Review of "Expert Report in the Matter of Rangen, Inc. -  
Availability of Spring Flow and Injury to Water Rights",  
December 20, 2012,  
by Charles E. Brockway, David Colvin, and Jim Brannon

Bern Hinckley, P.G.  
Hinckley Consulting  
Laramie, Wyoming

February 8, 2013

Figure 1 - ESPAM2.1 Elevation:Discharge Relationship

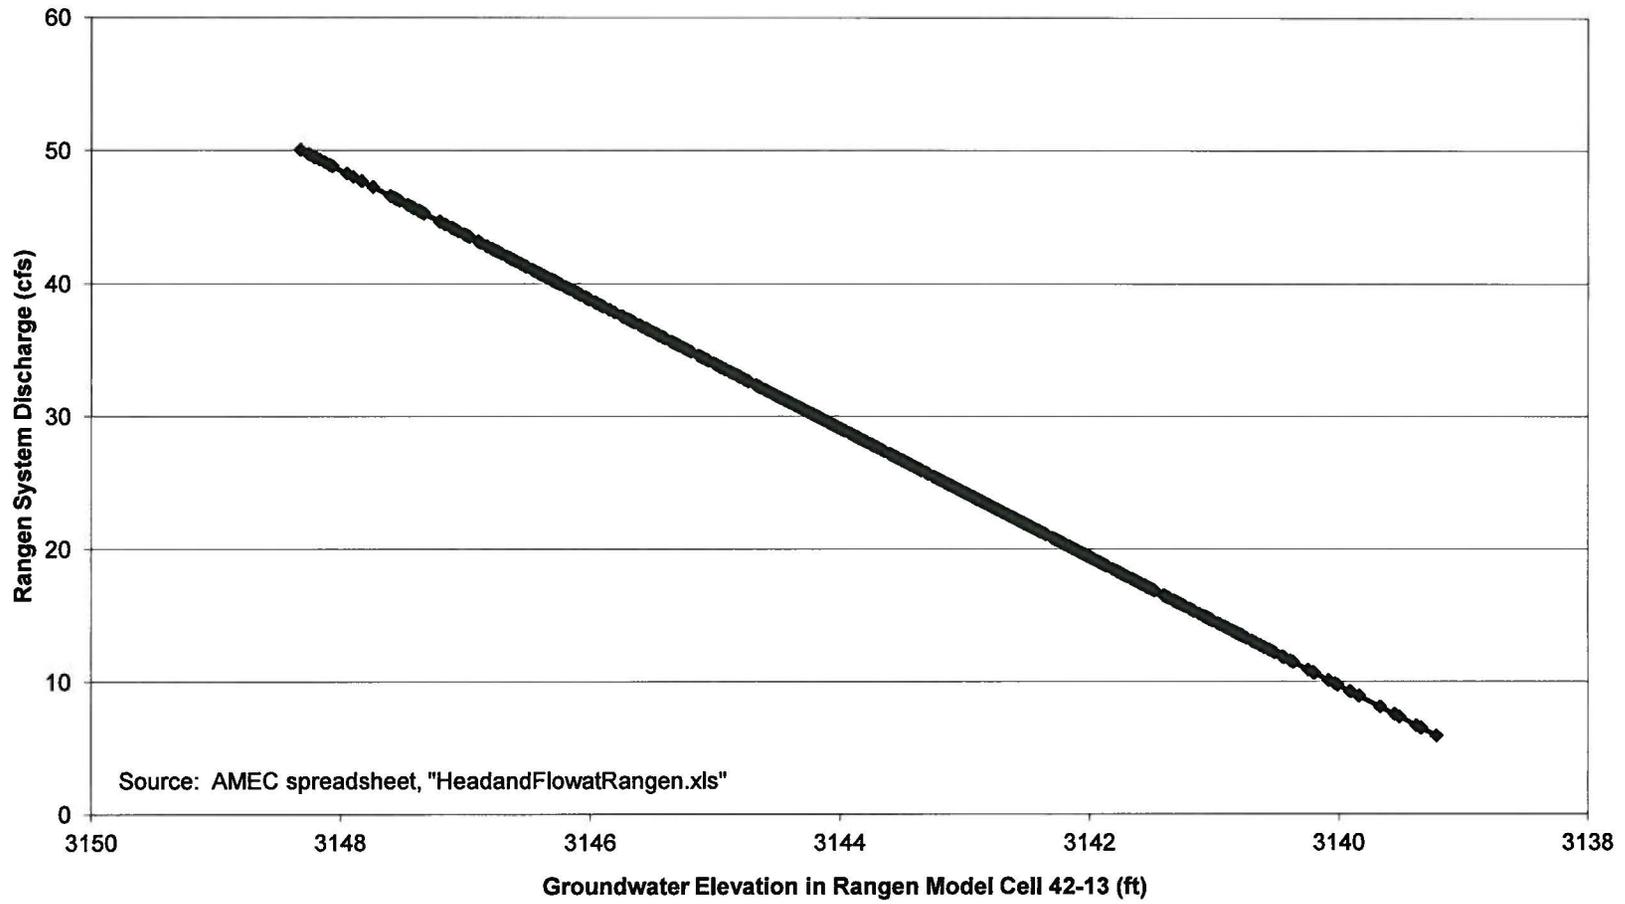
In contrast to the relationships established by measured data and documented by Brockway et al. in their Appendix C, Figure 1 (attached) presents output from ESPAM2.1 demonstrating the modeled relationship between aquifer water level and groundwater discharge for the model cell containing the Rangen discharge. As required by the mathematics presented by Brockway et al. (p. 24), the plot is a straight line, and when the water level falls to the elevation of the modeled discharge point - 3138 ft. - discharge falls to zero. ESPAM2.1 is structurally incapable of modeling the non-linear relationships shown on the seven figures of Brockway et al. Appendix C. (Additional manifestations of this problem are presented in my 2012 report; e.g. pp. 39-41.)

**Figure 2**  
**Rangen Discharge vs. Well 06S13E25DBC1 (IDWR Well No. 797)**  
**and ESPAM2.1**

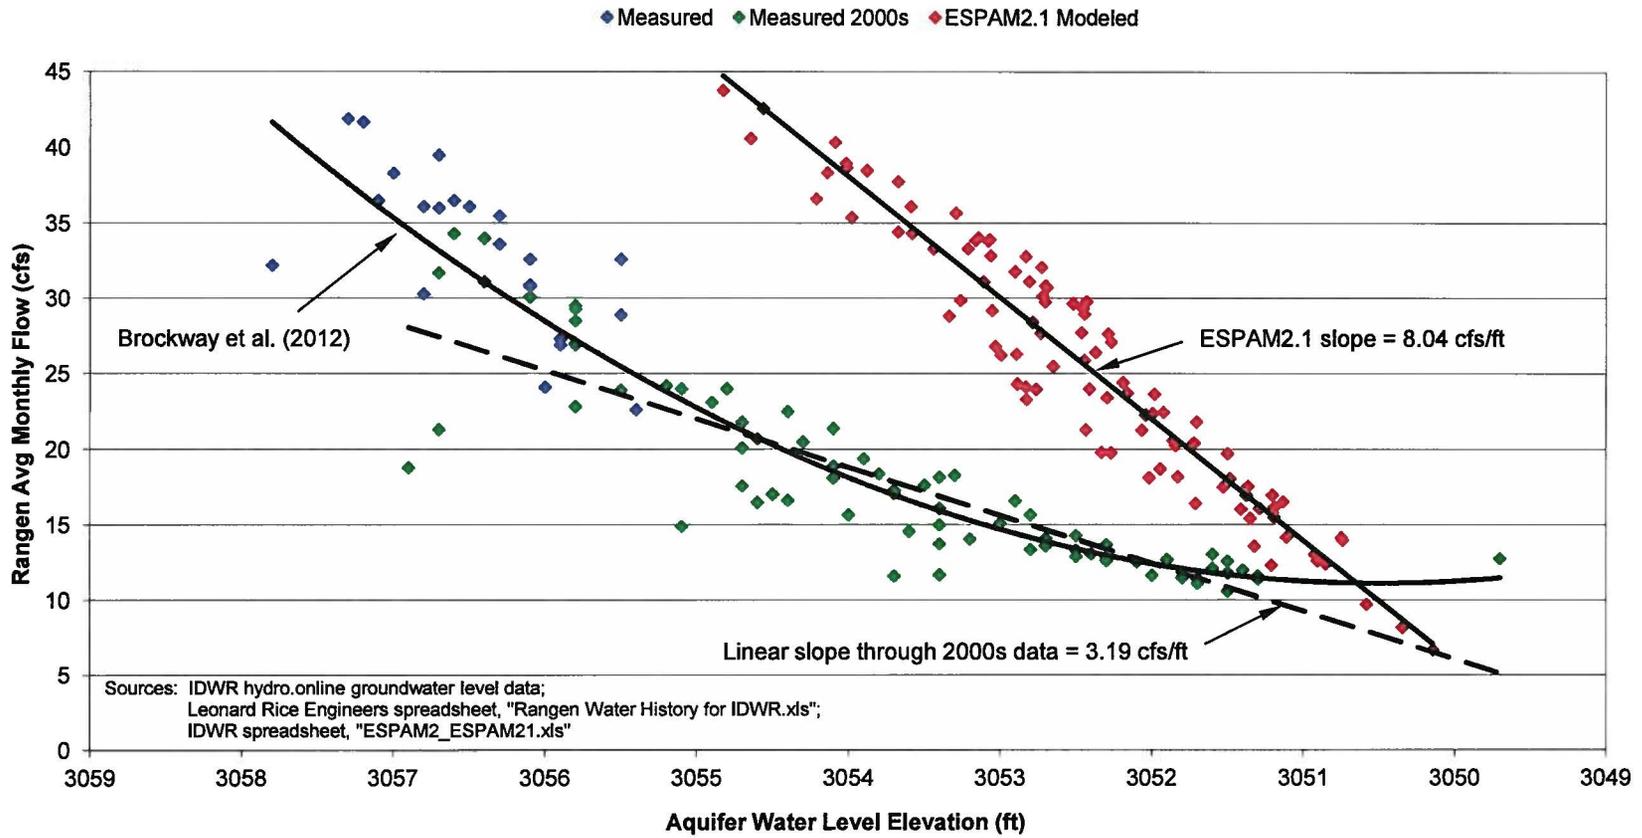
Figure 2 (attached) provides a comparison between ESPAM2.1 and measured data for well 06S13E25DBC1 (IDWR Well No. 797), the last of the wells plotted in Brockway et al. Appendix C<sup>1</sup>. There is some scatter in the ESPAM2.1 values relative to the rigidly

linear relationship of Figure 1 due to the impact of factors between this well and the Rangen discharge, 6 model cells away, but the linear structure required by ESPAM2.1 is clear. Also shown on Figure 2 is the polynomial relationship suggested by Brockway et al. for this well. While both the ESPAM2.1 and Brockway et al. curves indicate that Rangen flows generally rise and fall with aquifer water levels, there are substantial differences between the two:

- 1) the ESPAM2.1 water levels are consistently lower than the actual water levels<sup>1</sup>;
- 2) the ESPAM2.1 relationship between aquifer levels and Rangen flow is linear, whereas the actual relationship is not linear; and

- 3) most importantly, the slope through the most relevant portion of the measurement-based plot, the 2000s, is dramatically at odds with the ESPAM2.1 representation. The 2000s is the portion of the plot that most nearly represents current conditions, the background upon which curtailment would be imposed. Where ESPAM2.1 predicts an 8.0 cfs change in flow per foot change in aquifer water level at this location (the slope of a “least-squares” line fit to the ESPAM2.1 data), the actual measurements show a response of only 3.2 cfs/ft. (similarly approximated with a linear fit). Thus, the Brockway et al. presentation suggests a much smaller benefit from the change in aquifer levels that would result from curtailment, than does the ESPAM2.1 evaluation.

**Figure 3a**  
**Rangen Discharge vs. Well 07S14E31ABA1 (IDWR Well No. 991)**  
**ESPAM2.1 Modeled**

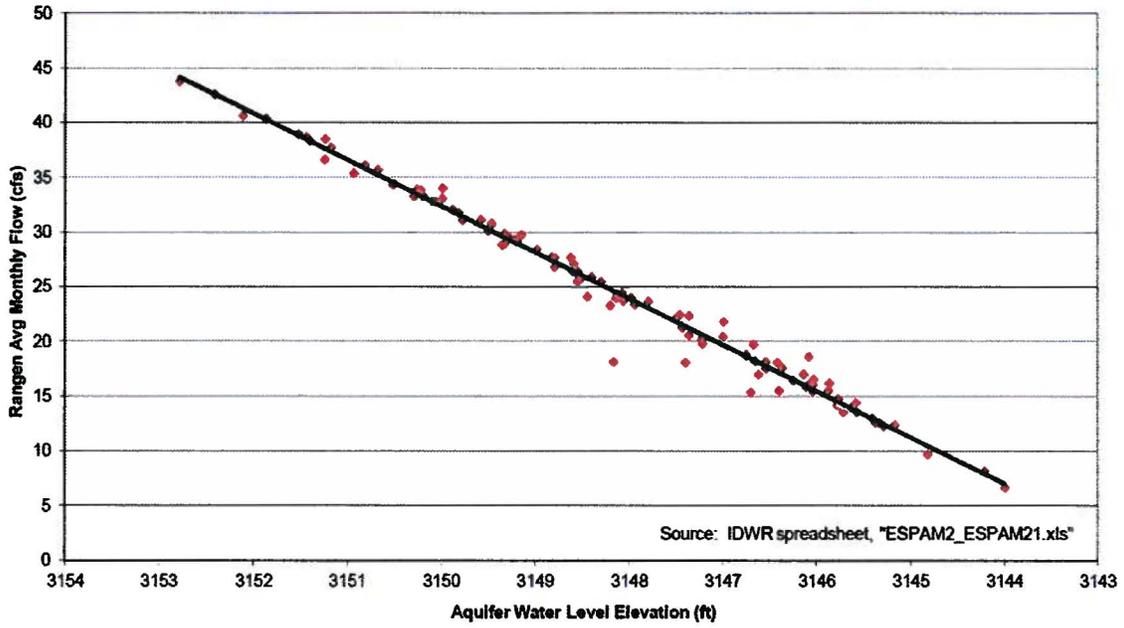
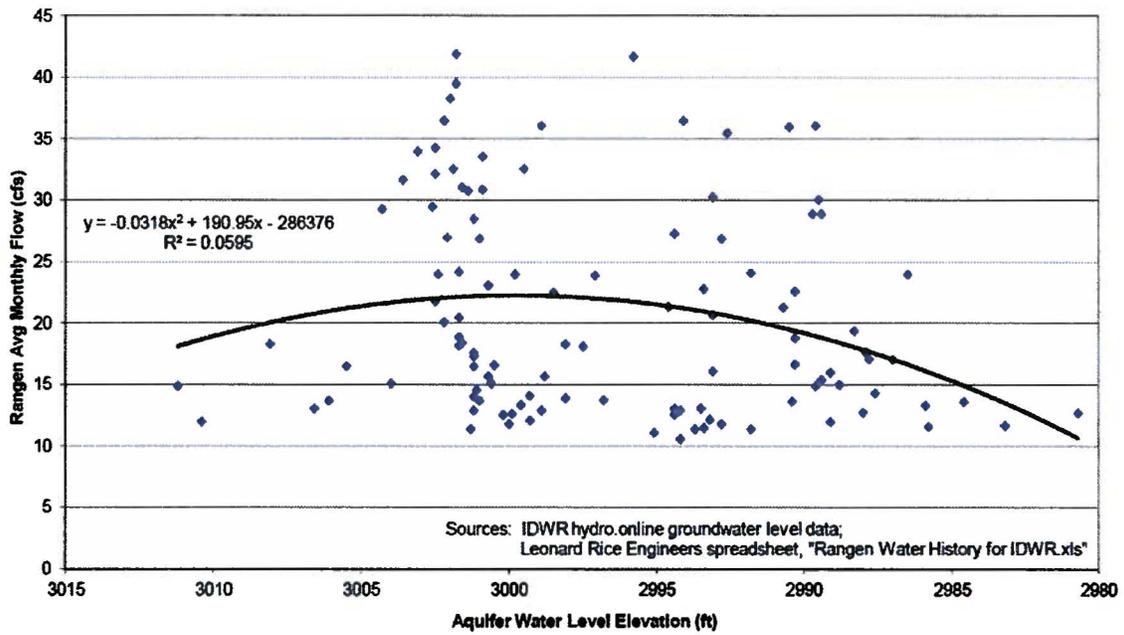
Figure 3 (attached) provides data for an additional well (IDWR Well No. 991) in the same manner as Brockway et al. Appendix C. Figure 4 (attached) shows the location. This well is approximately the same distance from the Rangen discharges as IDWR Well No. 989, the closest of the Brockway et al. Appendix C wells. ESPAM2.1 models a linear relationship between the water levels at this point and the Rangen discharges, with the two rising and falling in close correspondence (Figure 3a), as is required by the basic structure of the model. The actual water-level data (Figure 3b) present a very different picture. The actual water levels are all substantially lower than simulated by ESPAM2.1 (compare the x-axes of Figs. 3a and 3b). And the actual water levels show no relationship with the Rangen flows, despite this well being only 0.7 miles away. These discrepancies are the result of there being little if any connection between the aquifer supplying Rangen and the aquifer to which this well is responding. Yet ESPAM2.1 models this area as one, thick, continuous aquifer. I provide substantial additional discussion of this issue in my 2012 report (e.g. pp. 30-34, 37-39).
